Access Compliance Report Public Rights-of-Way (Curb Ramps)

Main Street: BUSHWOOD_CIR Cross Street: FLINTRIDGE_AVE Location: SW

ADA ID: RPRK211104134835 Ramp Type: Type 4 - Parallel Initial Pass/Fail: Pass Overall Compliance: No Severity Score: 25

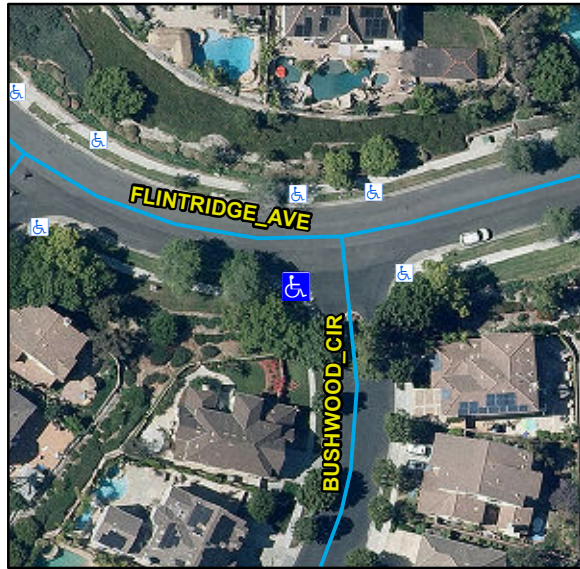
Compliance	Description	Data	Compliance	Description	Data
N/A	Ramp Length LT (in)	111	N/A	Ramp Length RT (in)	115
Yes	Ramp Width LT (in)	54	Yes	Ramp Width RT (in)	54
Yes	Ramp Run Slope LT (%)	6.3	Yes	Ramp Run Slope RT (%)	5.5
Yes	Ramp Cross Slope LT (%)	0.1	Yes	Ramp Cross Slope RT (%)	0.2
N/A	Landing Present	No	No	DWS Provided	No
N/A	Landing Length (in)	N/A	N/A	DWS Contrast	N/A
No	Landing Width (in)	N/A	N/A	DWS Length (in)	N/A
No	Landing Run Slope (%)	N/A	N/A	DWS Full Width	N/A
No	Landing Cross Slope (%)	N/A		DWS Offset Type	N/A
N/A	Landing Movement Obstructed?	No	N/A	DWS Offset Left (in)	N/A
	Landing Movement Type	Curb	N/A	DWS Offset Right (in)	N/A
N/A	Landing Shared	N/A			
N/A	Clear Space	Yes			
N/A	Clear Space To Crosswalk (in)	48			
N/A	Marked Crosswalk 1	No	N/A	Marked Crosswalk 2	No
	Crossing 1 Direction	E		Crossing 2 Direction	N
N/A	Marked Crosswalk 1 Width (in)	N/A		Marked Crosswalk 2 Width (in)	N/A
N/A	Ramp Inside Crosswalk 1	N/A	N/A	Ramp Inside Crosswalk 2	N/A

Crossing 1 Slope (%)	6.7		Crossing 2 Slope (%)	2.2
	Crossing 1 Cross Slope (%)	3.1		Crossing 2 Cross Slope (%)	5.4
Yes	Gutter Ponding	No	Yes	Curb Slope	7.1
Yes	Gutter Lip Height (in)	0		Road Run Slope (%)	1.8
No	Gutter Run Slope (%)	10.5		Road Cross Slope (%)	9.5
No	Gutter Cross Slope (%)	2.1	No	Perpendicular Joint Present	No
Yes	Overall Surface Condition	Acceptable			
	Cross Gutter Present?	No		Spandrel Present?	No
	Replace Cross Gutter?	N/A		Replace Spandrel?	N/A

Remove & Replace Curb Ramp With Two New Directional Ramps or Equivalent. Remove & Replace Gutter.
